CITY OF ST. HELENS PLANNING DEPARTMENT

MEMORANDUM

TO: Planning Commission acting as the Historic Landmarks Commission
FROM: Jennifer Dimsho, AICP, Associate Planner
RE: 230 Strand Street (Courthouse Annex)
DATE: July 27, 2022

RIVERFRONT GUIDELINES NARRATIVE RESPONSE
COLUMBIA COUNTY COURTHOUSE ANNEX TI #2141

1 Existing East Elevation
SCALE: 1/8" = 1'-0"

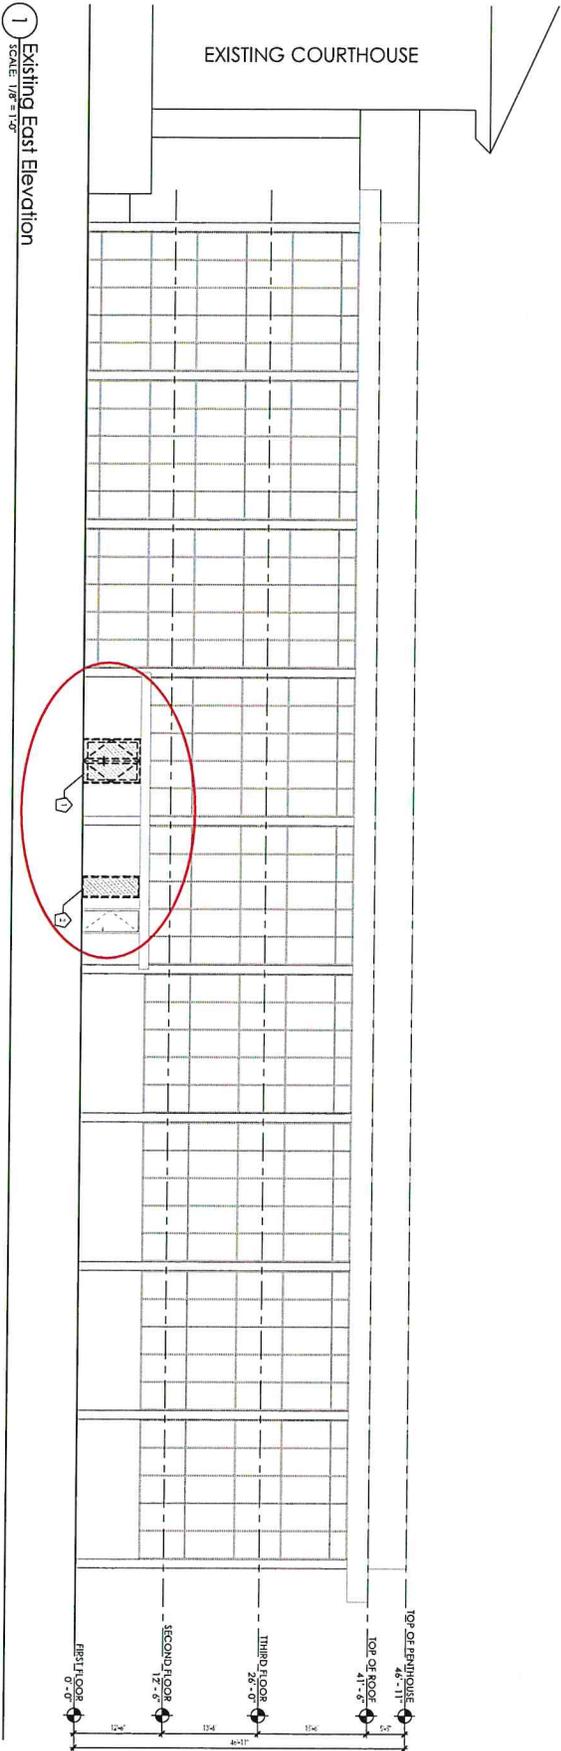
Although an existing original window will be replaced with a door, it is not a major contributor to the character of the building given its current condition is covered by a metal mesh security screen,

its less visible east side location, and its relation to the other windows on the building. The size of the existing window is also generally the same size as the door which will replace it.

Response: The window proposed to be replaced is a minor idiosyncratic condition that occurs in just one location and is not a major contributor to the building's character. This condition also occurs on the less public parking-lot (east) side of the building. The proposed replacement of this window with an architecturally compatible door, providing access isolated from other building functions and occupants, is a necessary alteration to improve the level of safety for mail delivery at the building. The proposed alteration meets the intent of the Guidelines by maintaining the existing wall/window ratio, and remaining compatible with the original composition and finishes of the building.

1 Proposed East Elevation
SCALE 1/8" = 1'-0"

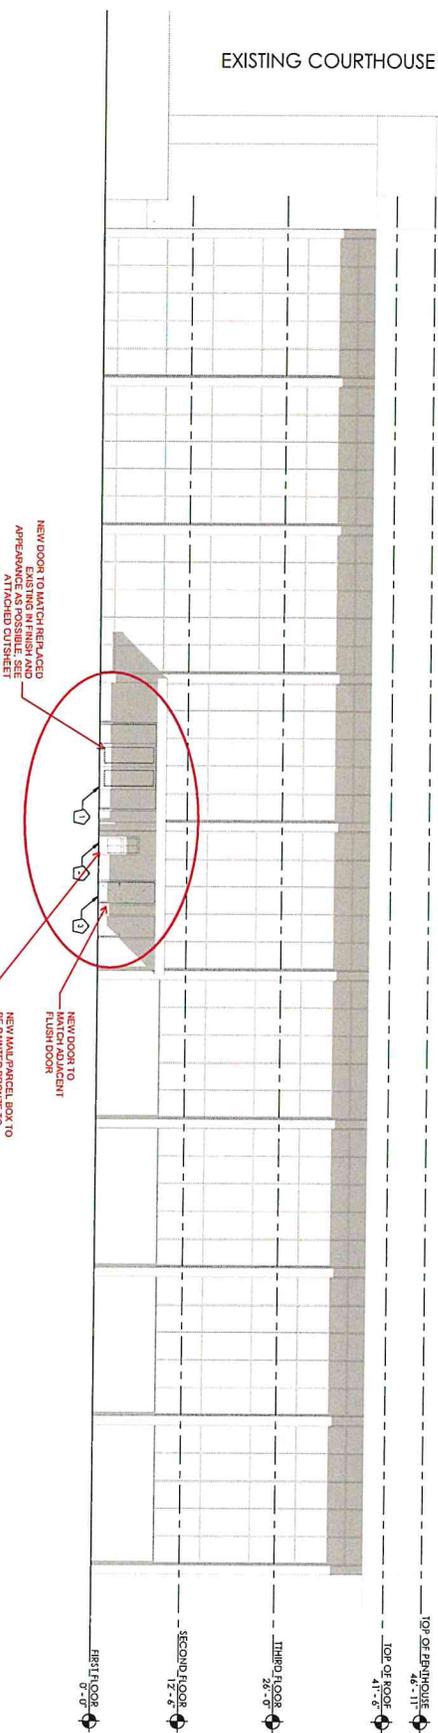
Although the main entry door will be replaced because of its poor condition, the original entry (location, layout, and appearance) will remain the same. Access will also improve because of its automation.

Materials should be replaced with similar material types to maintain the original appearance of the structure. The proposed door finishes and bronze USPS parcel box are specified to closely match existing building materials and color.

Response: The proposed entry door replacement will closely match the existing condition while remediating a failing condition providing greater accessibility to public departments inside the building. The proposed new door will replace an existing idiosyncratic window, currently fitted with a metal mesh security screen, with an architecturally compatible new door. These alterations meet the intent of the Guidelines by preserving the original building's entry sequence, specifying materials and finishes similar to the existing, and improving means of access and use of the building.

Response: The proposed doors and exterior mail/parcel box are specified to closely match existing materials, detailing, and colors. This meets the intent of the Guidelines to maintain visual continuity across the façade.
